Planning & Zoning Commission Regular Meeting

Wednesday, March 08, 2023 at 6:30 PM

- 2. Conduct a public hearing on a Subdivision Preliminary Plat for the Shadowglen Subdivision, three hundred and sixty one (361) lots on 103.728 acres, more or less, and being located near the intersection of Gregg Manor Rd and Rector Loop, Manor, TX.**

- 3. Conduct a public hearing on a Subdivision Preliminary Plat for the Monarch Ranch Subdivision, four hundred (400) lots on 123.5 acres, more or less, and being located near the intersection of Gregg Ln and FM-973, Manor, TX.**

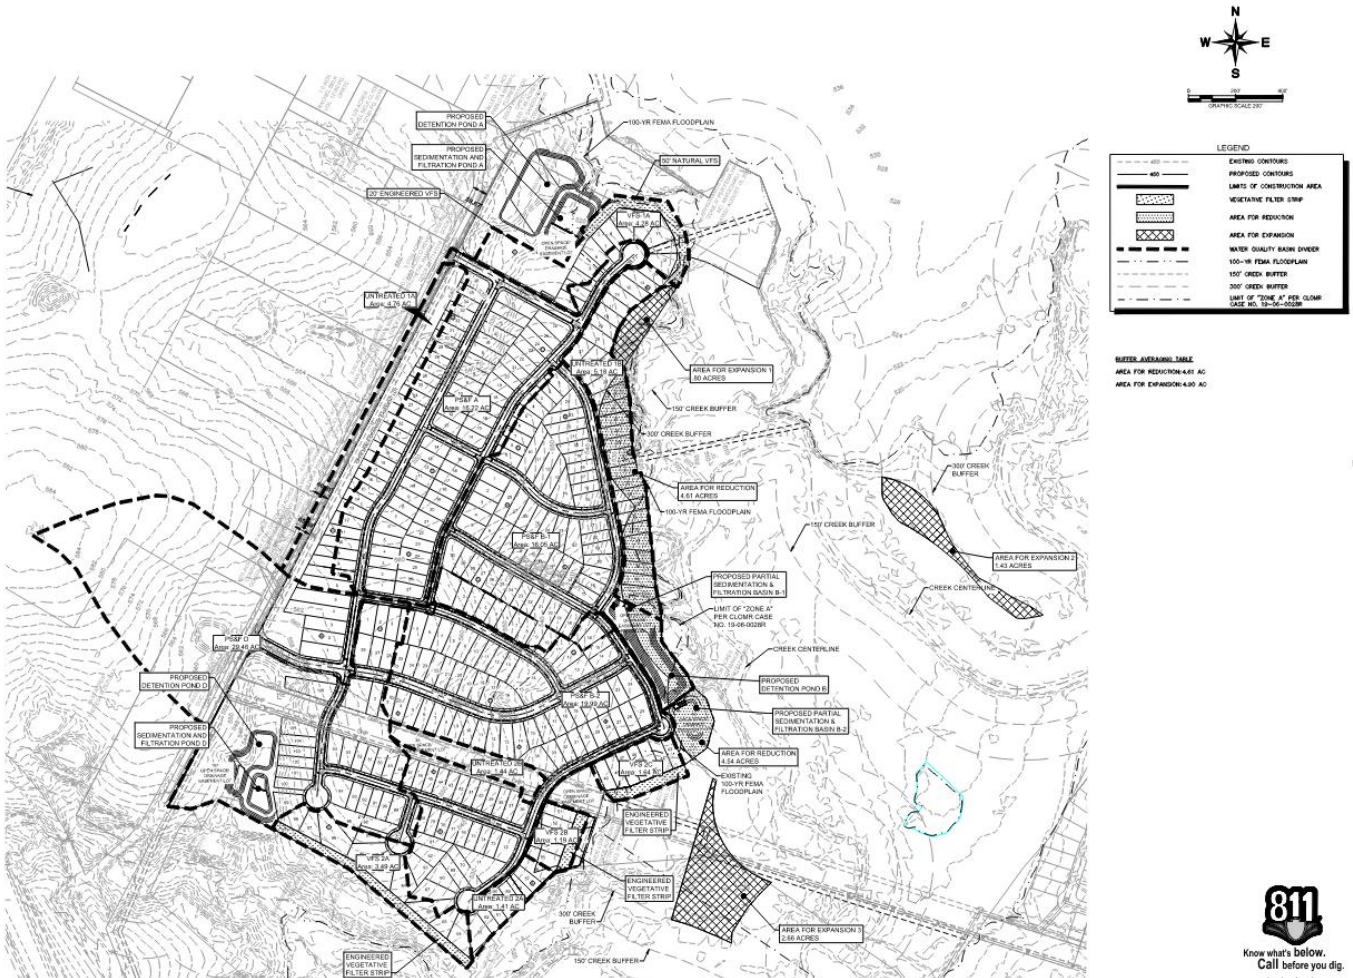
5. An exception request would need to be approved by the Division Director under 482.941.j.7. for the waterway buffer encroachments noted.

Please submit your request for approval.

Response: As discussed in our previous comment response a buffer averaging is proposed for the residential lots and Pond B located within the 300' setback per COA ECM 1.5.2.D. The 4.61ac area of reduction shown on Exhibit B will be averaged with three areas of expansion that account for a total of 4.9 acres. See exhibit G below and on sheet 12 of the prelim plan.

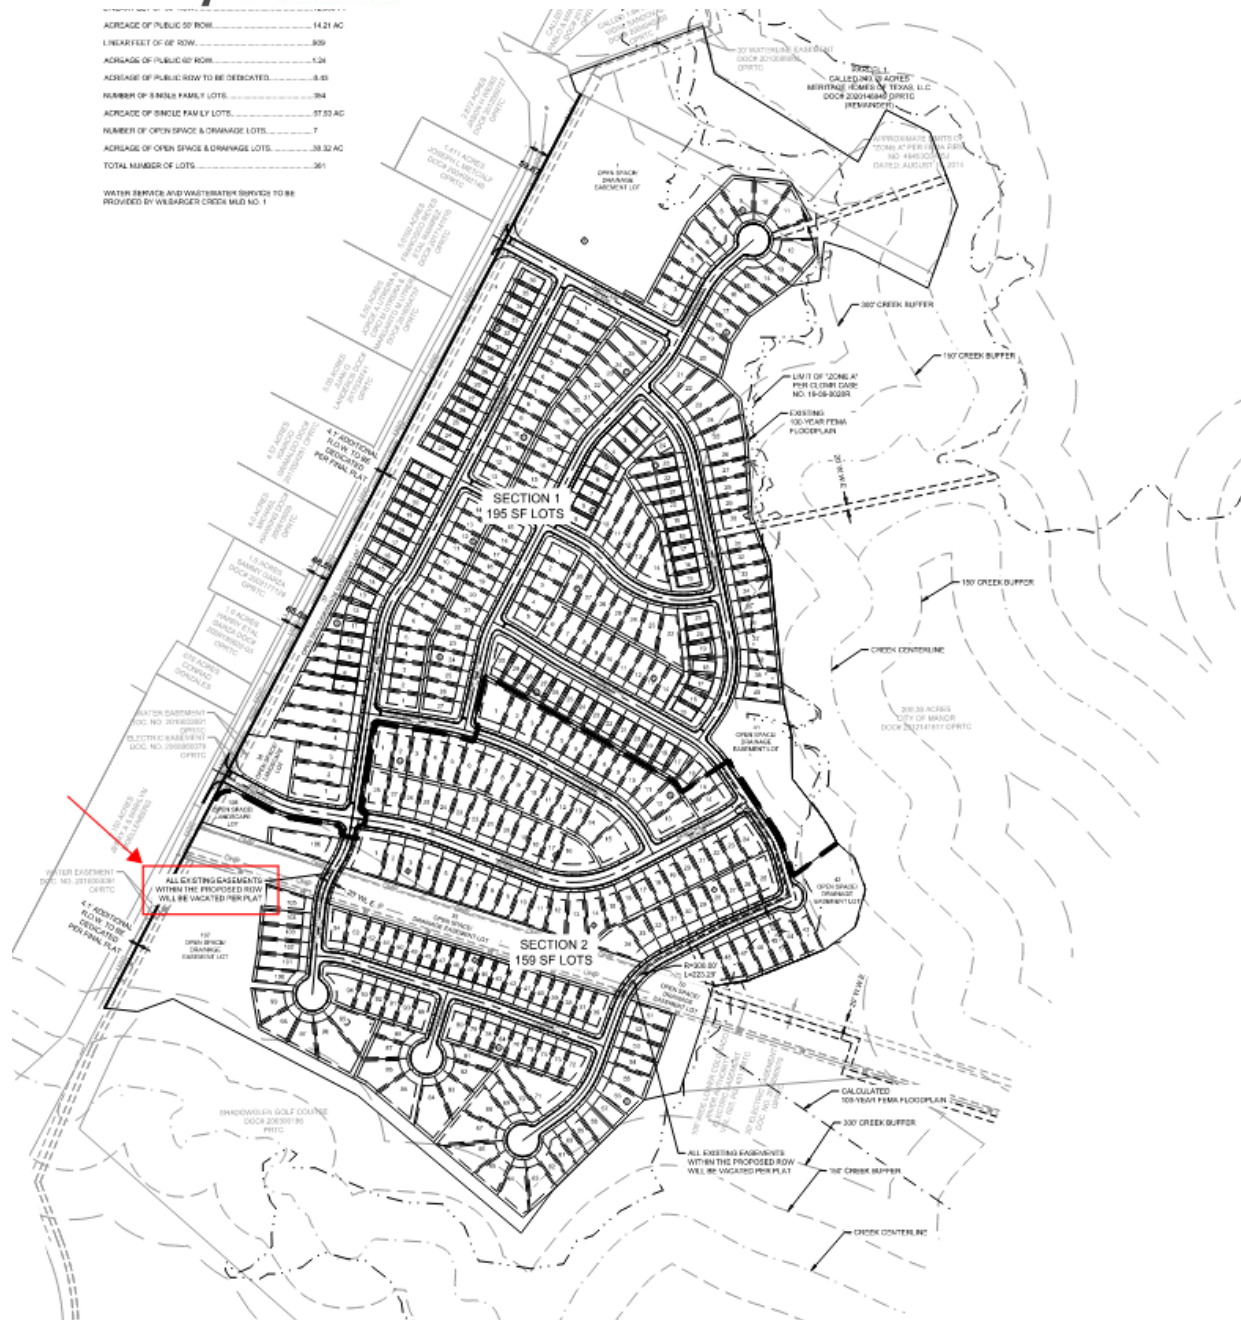
Update comment 1/23/23: Please confirm the location of the note; I did not find it on the Preliminary Plan.

Response: Acknowledged. The vacation note is shown below on the overall preliminary plan.

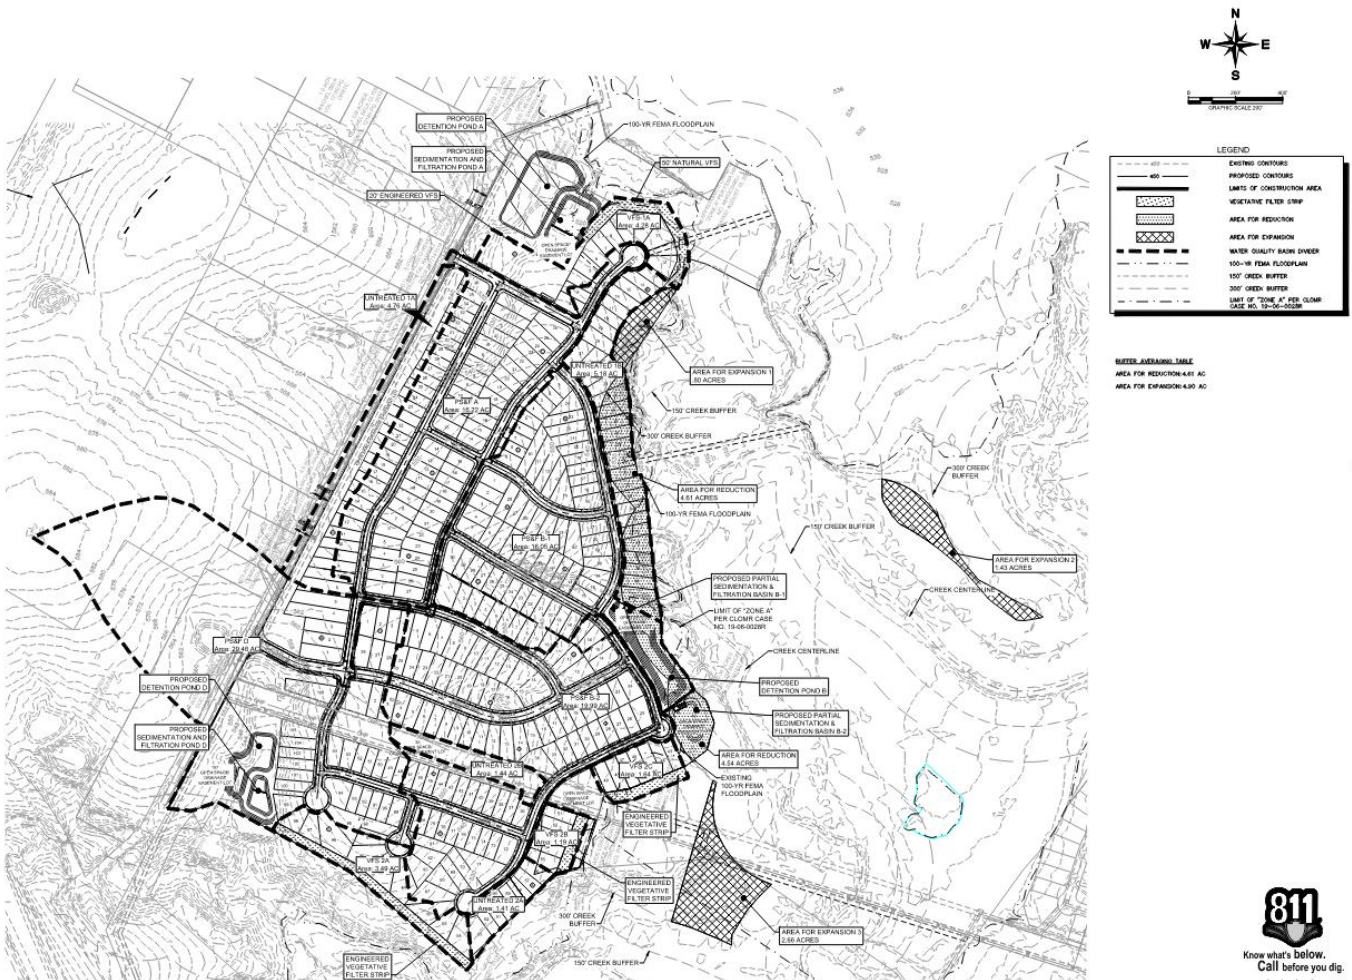
Please submit your request for approval.

Response: As discussed in our previous comment response a buffer averaging is proposed for the residential lots and Pond B located within the 300' setback per COA ECM 1.5.2.D. The 4.61ac area of reduction shown on Exhibit B will be averaged with three areas of expansion that account for a total of 4.9 acres. See exhibit G below and on sheet 12 of the prelim plan.

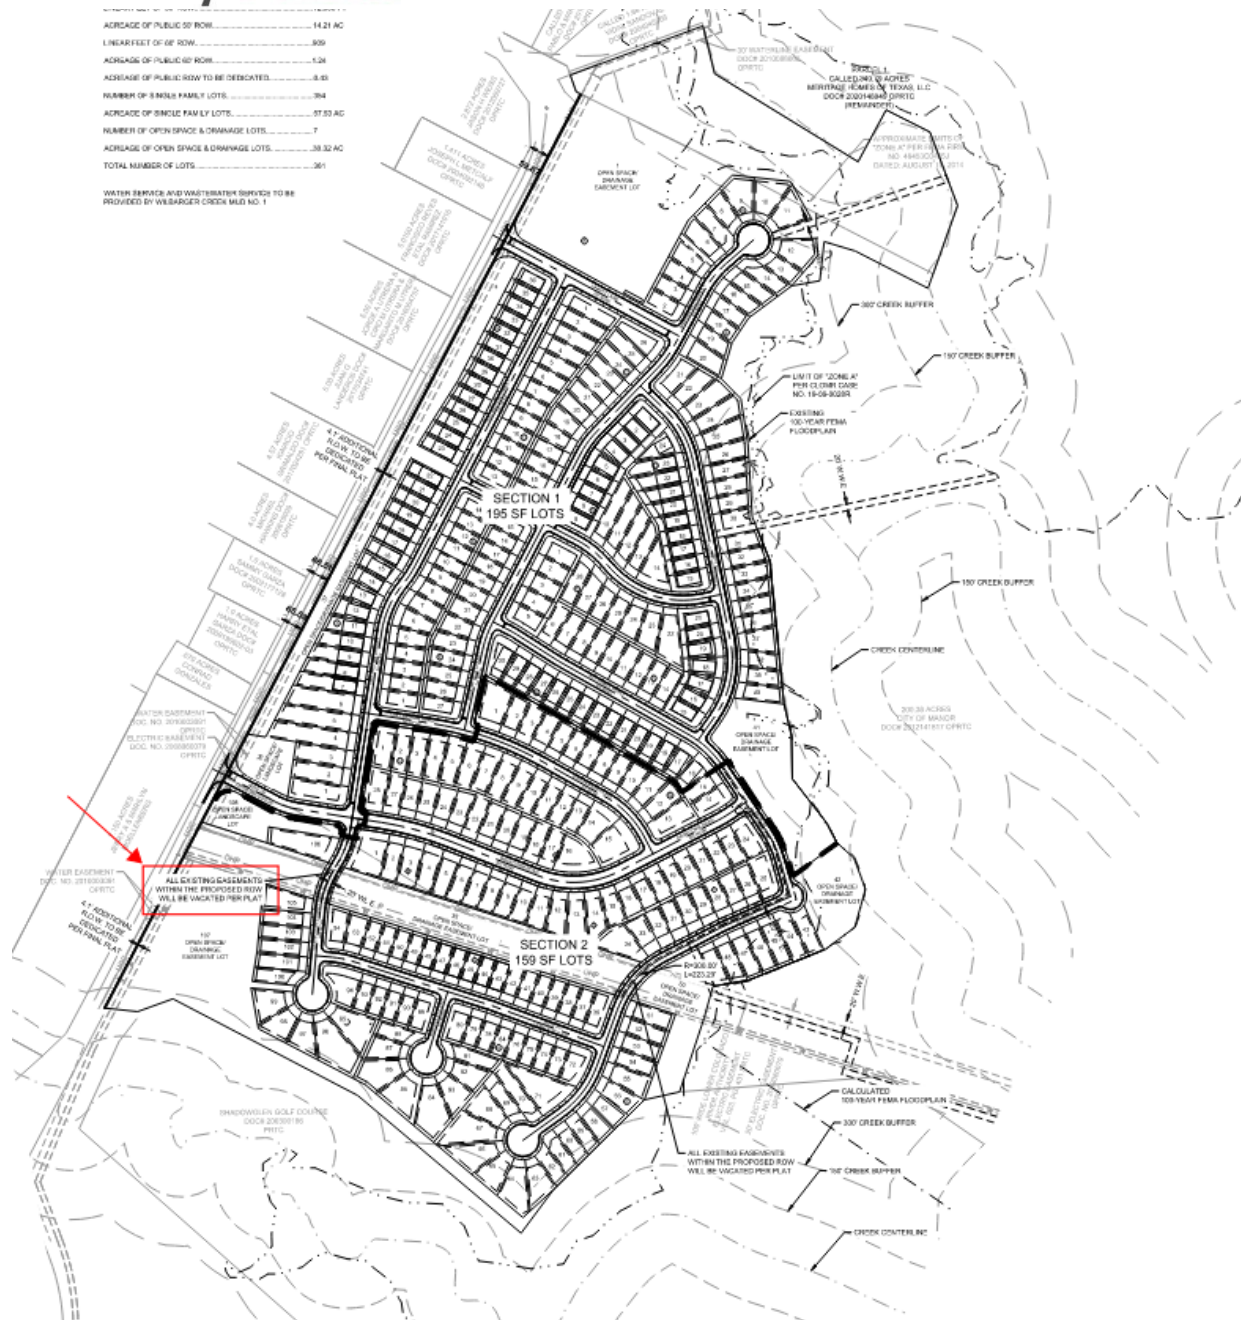
Update comment 1/23/23: Please confirm the location of the note; I did not find it on the Preliminary Plan.

Response: Acknowledged. The vacation note is shown below on the overall preliminary plan.

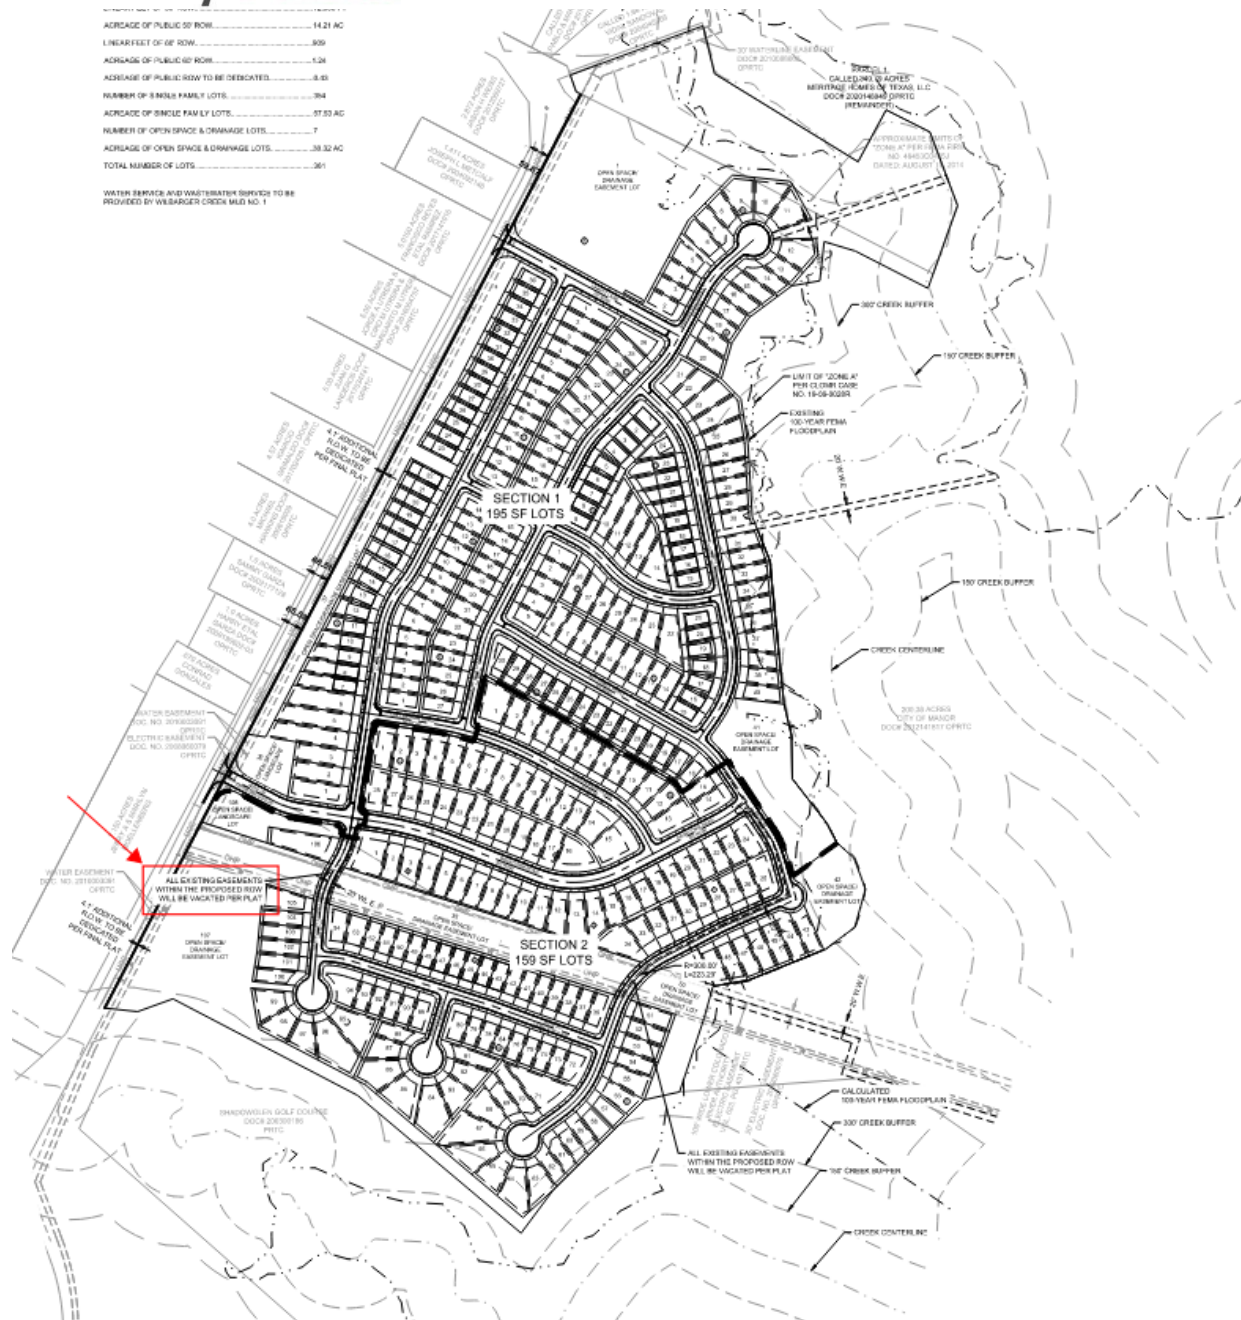
Update comment 1/23/23: Please confirm the location of the note; I did not find it on the Preliminary Plan.

Response: Acknowledged. The vacation note is shown below on the overall preliminary plan.
